Bryant Development and Review Committee Meeting

3. Hillcrest Addition Subdivision - 3927 Springhill Road

Tim Lemons - Requesting Recommendation for Preliminary Plat Approval

Please accept this letter in response to your latest comments as provided in an email on October 22, 2024. I will address the items in the order expressed (my response is shown in ***bold italicized***):

Project No.	24-018
Date:	JULY 9, 2024
Scale:	1" = 20'
Drawn By:	B. Judd
Sheet:	5 of 10

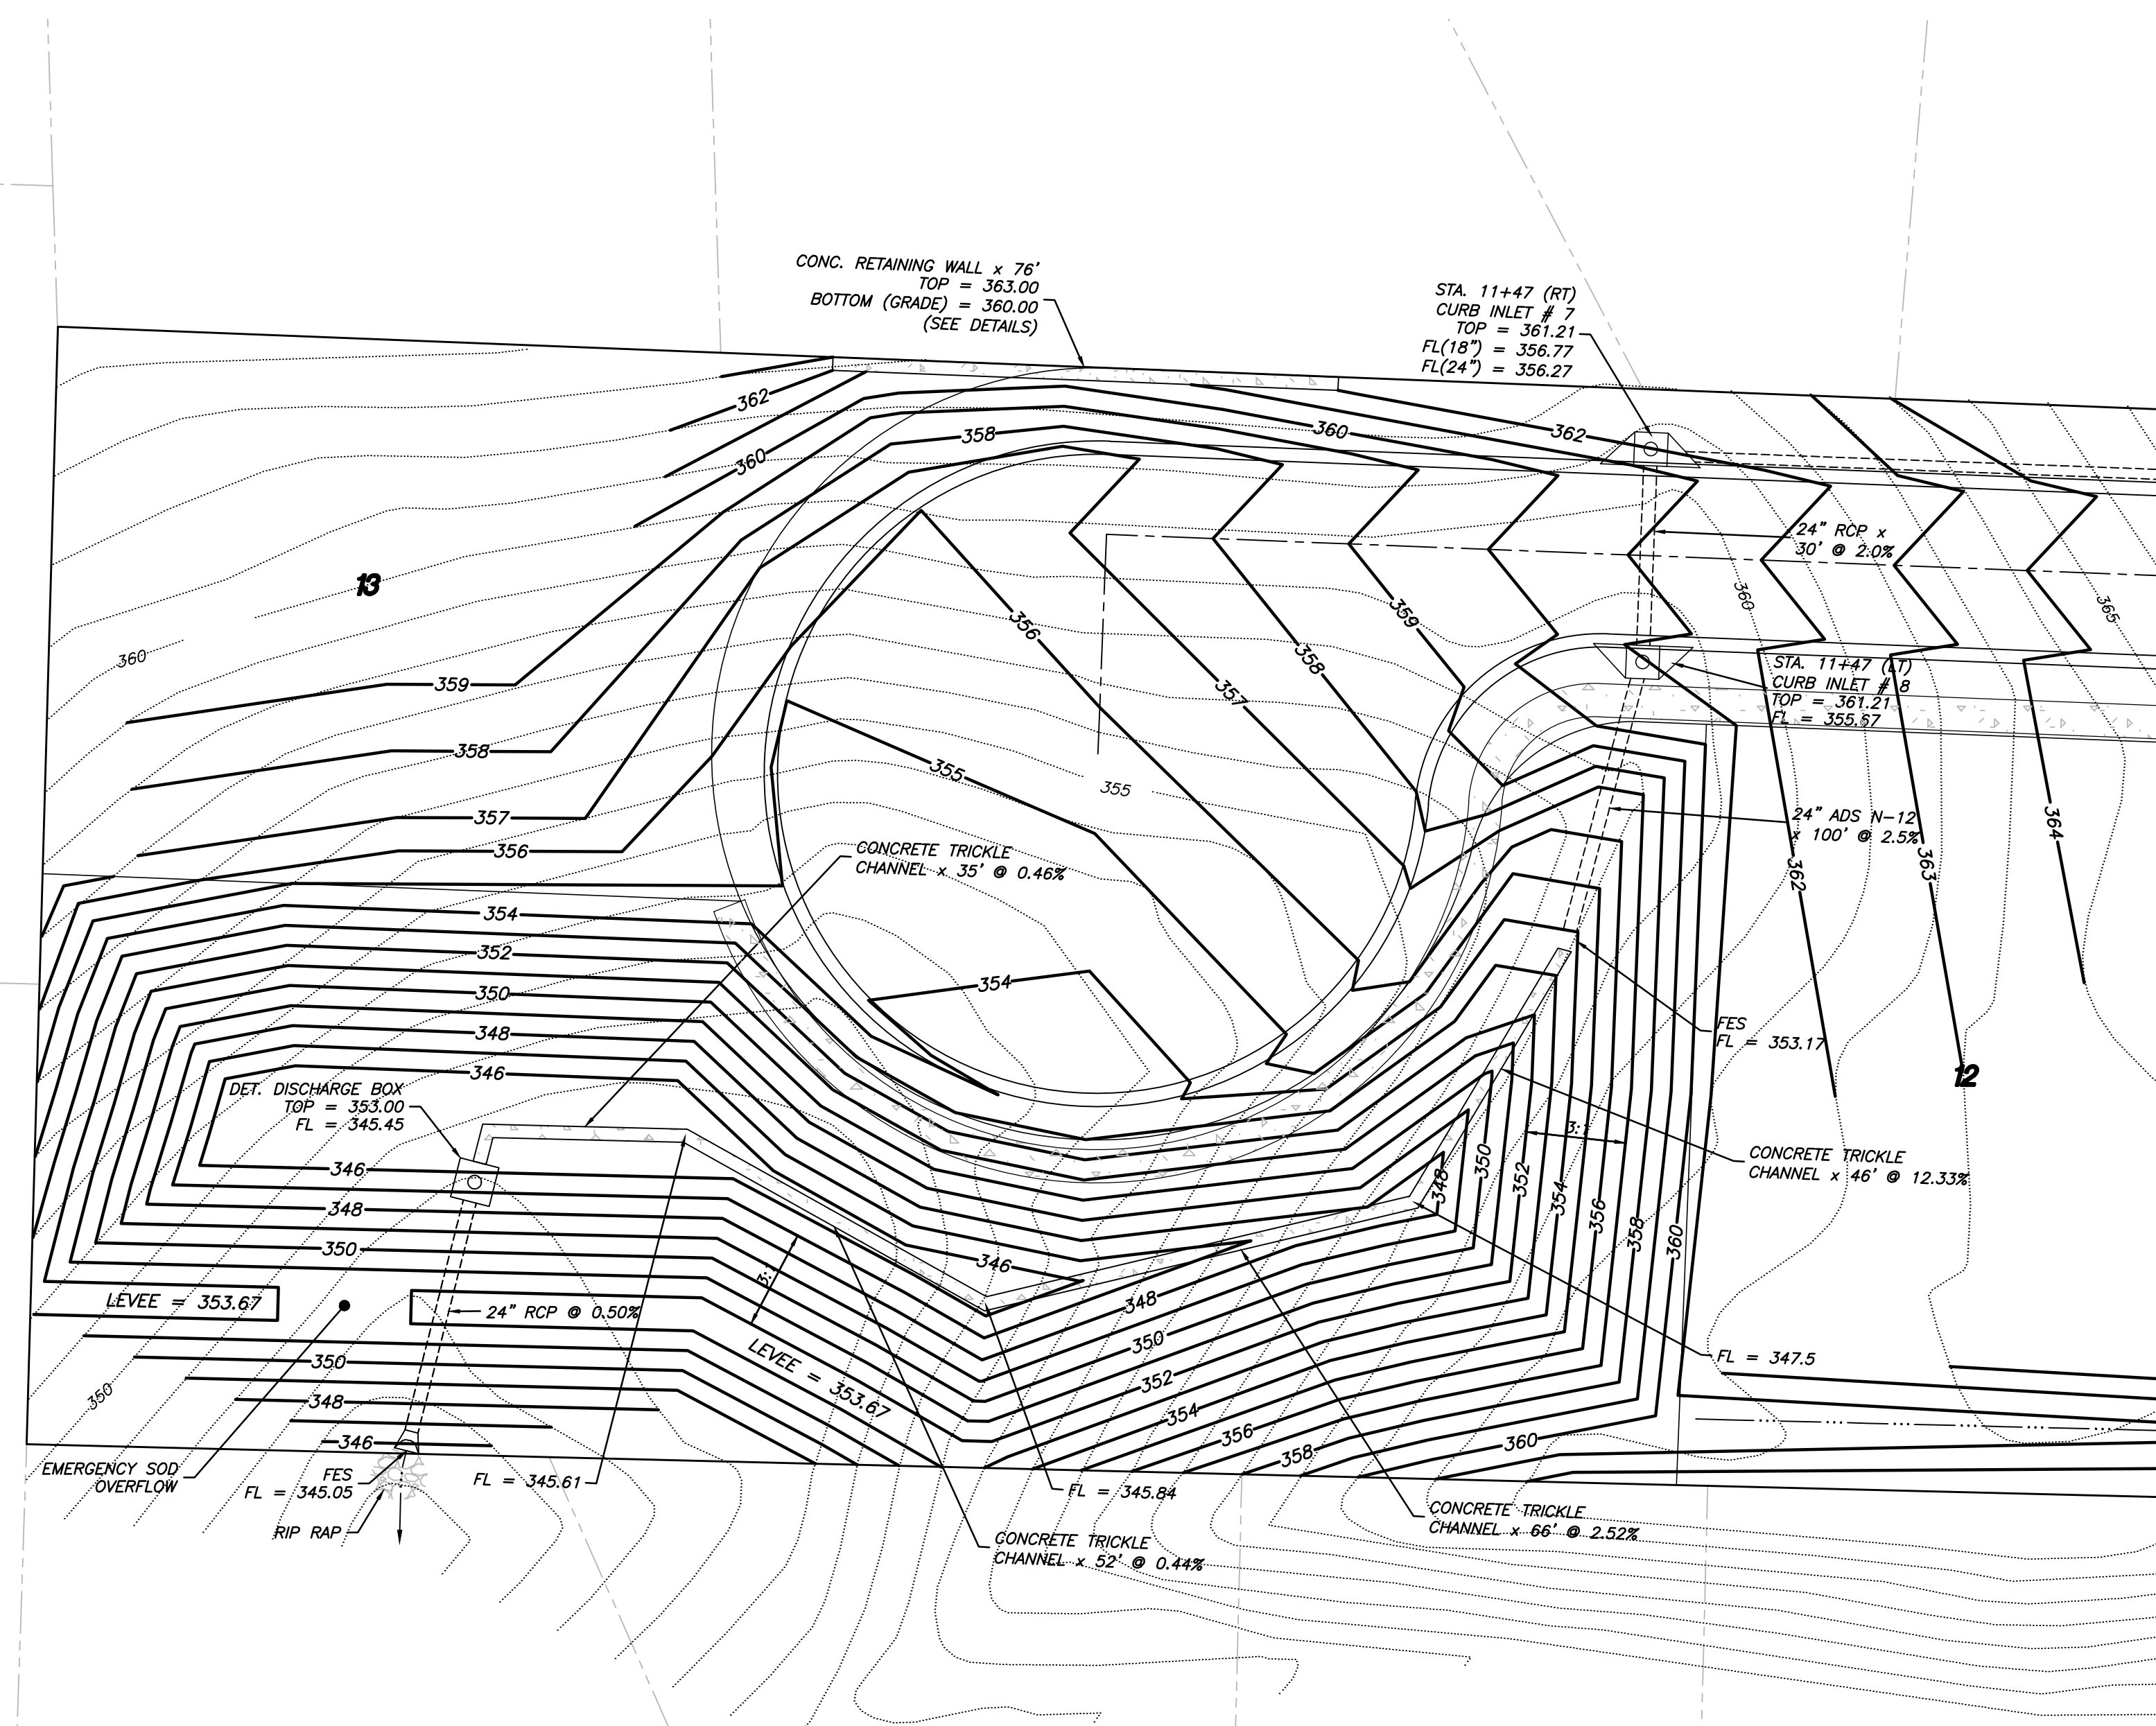
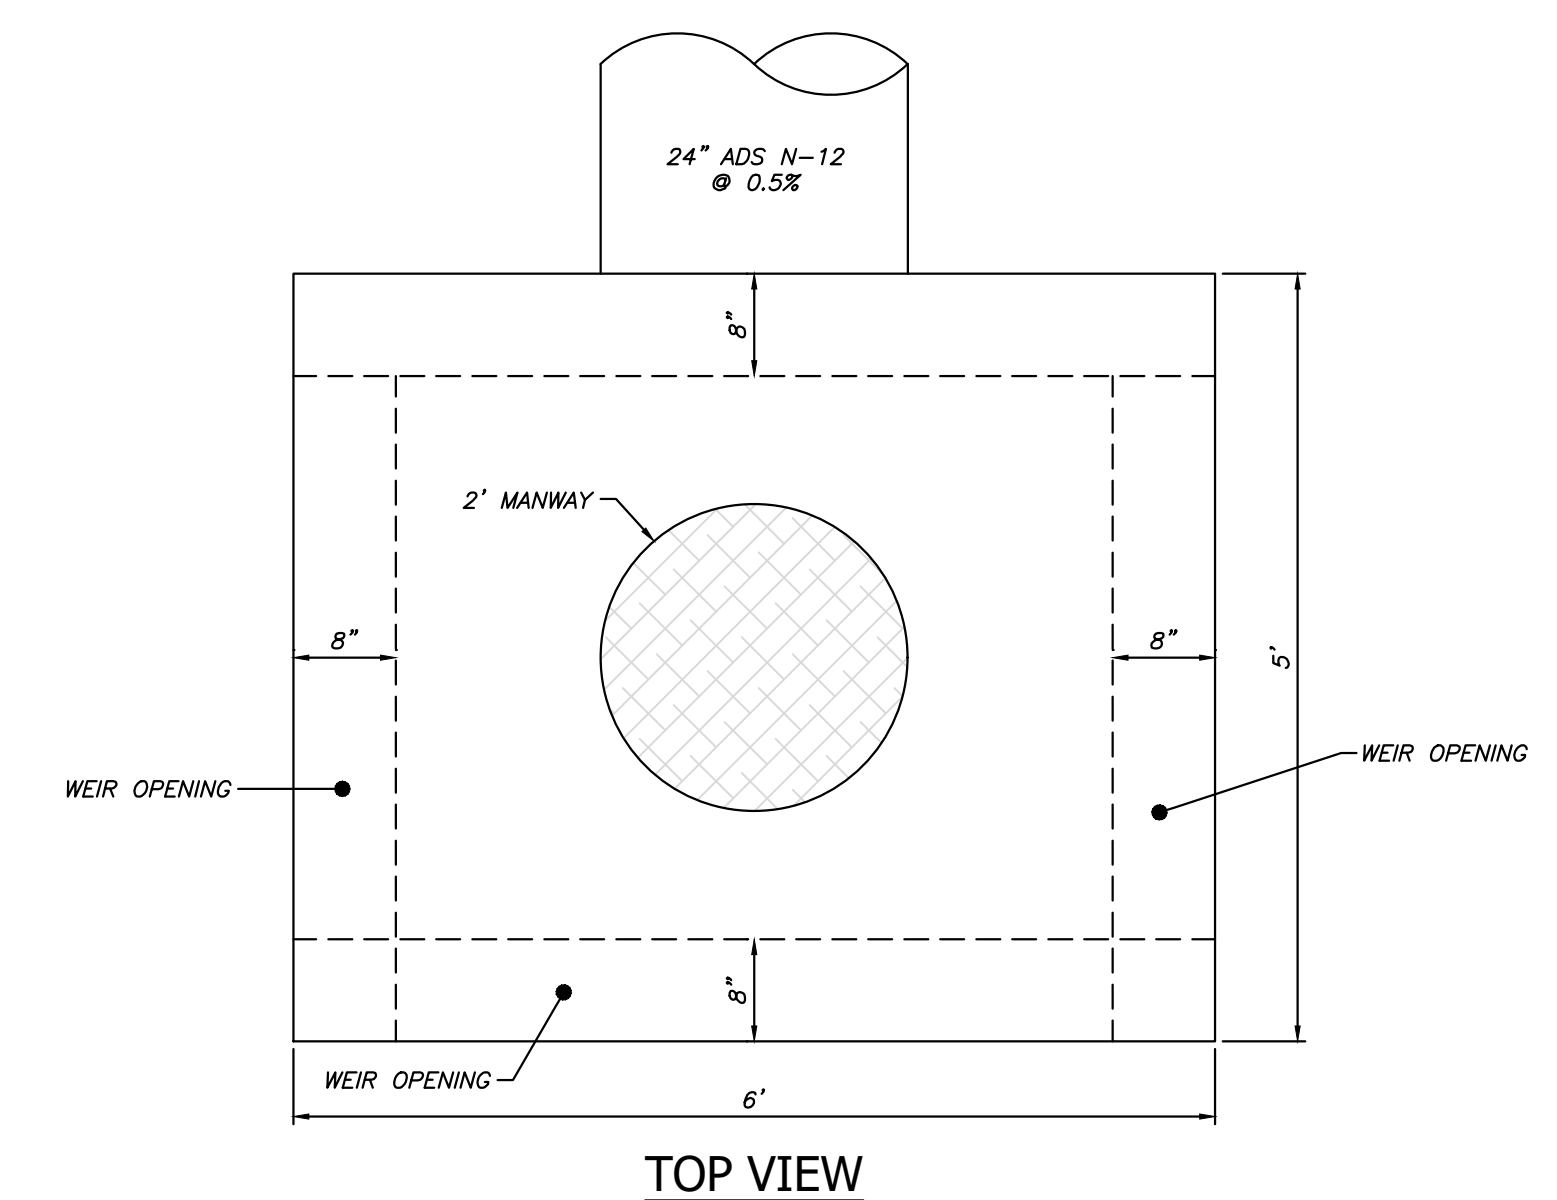
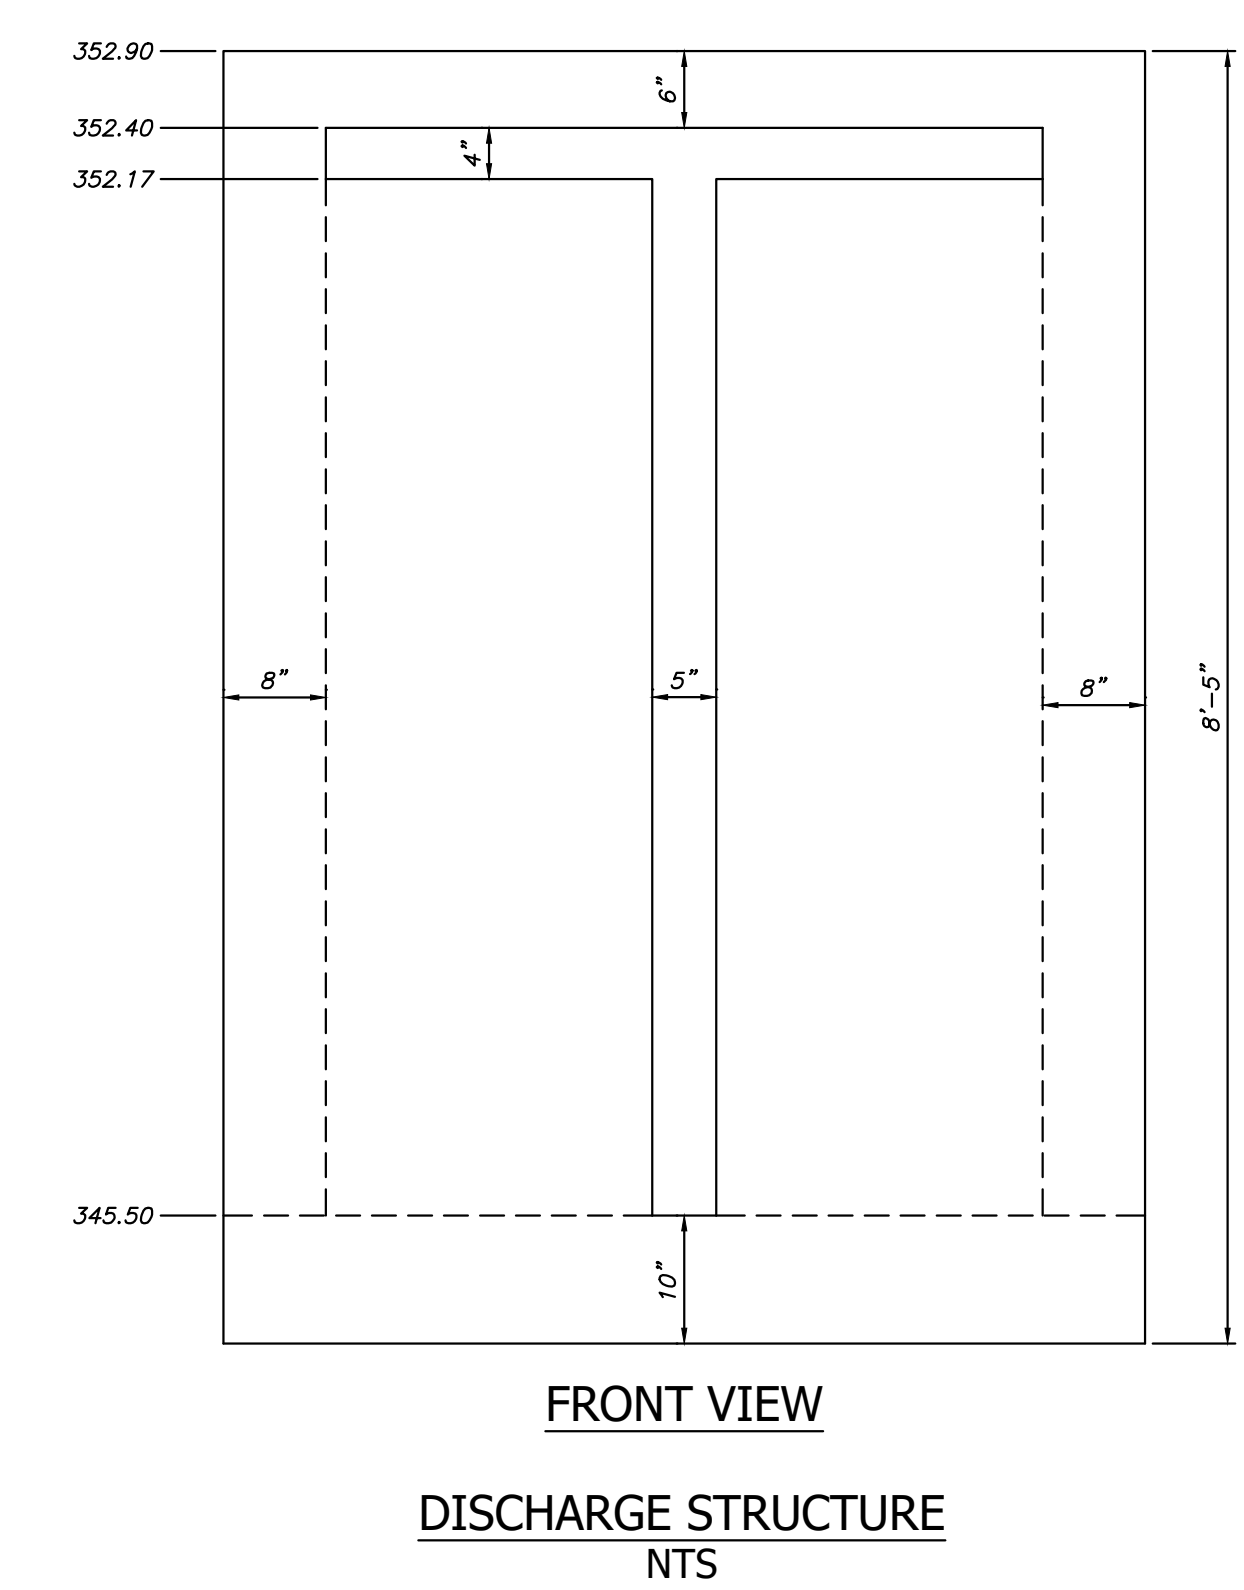
3. Sheet 5 of 10, show inlet numbers. ***Added as requested.***
4. Sheet 5 of 10, Is the top 4" slot all the way around the box beneath the top? ***Yes. I have added additional information on this detail to better represent this item.***

GRADING PLAN
HILLCREST ADDITION
 PART OF THE SE 1/4 OF SECTION 17, T-1-S, R-14-W
 CITY OF BRYANT, SALINE COUNTY, ARKANSAS

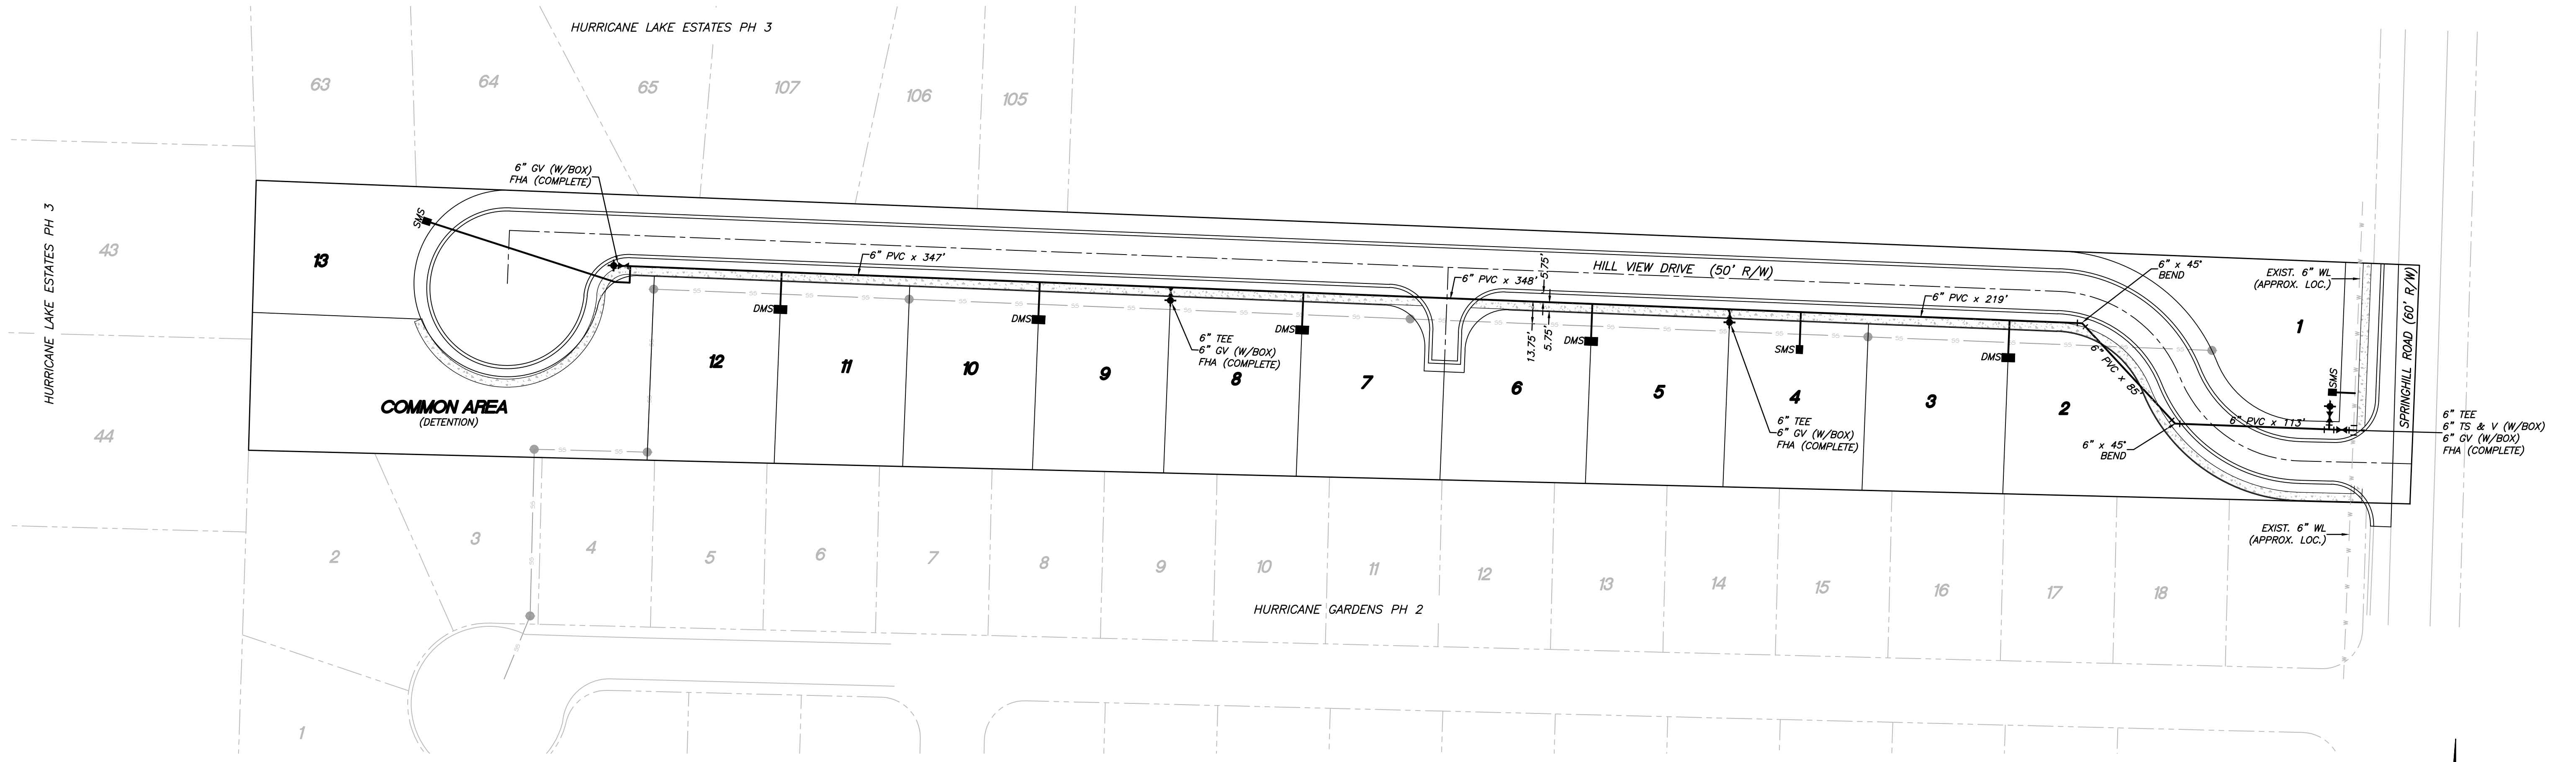
- iii. The pavement structure detail shown does not match the typical street section, see 3.b.ii. above. **This has been revised.**
 - c. On sheet 3:
 - i. The grading plan shows that grades will continue to slope south from the south curb and gutter on the street, unlike shown in the drainage calculations (see section 4 below). **Grading Plan has been revised.**

- ii. Significant stormwater is being allowed to drain off of the site to the south, it is recommended that the engineer look at diverting flow to the detention pond. ***A swale has been added along the South property line to assist in diverting flow away from homes within Hurricane Gardens. See revised plans.***

- iii. Will a separate drainage plan be developed for the plans? Profiles for the storm drainage? ***Drainage profiles have been added to the plans.***
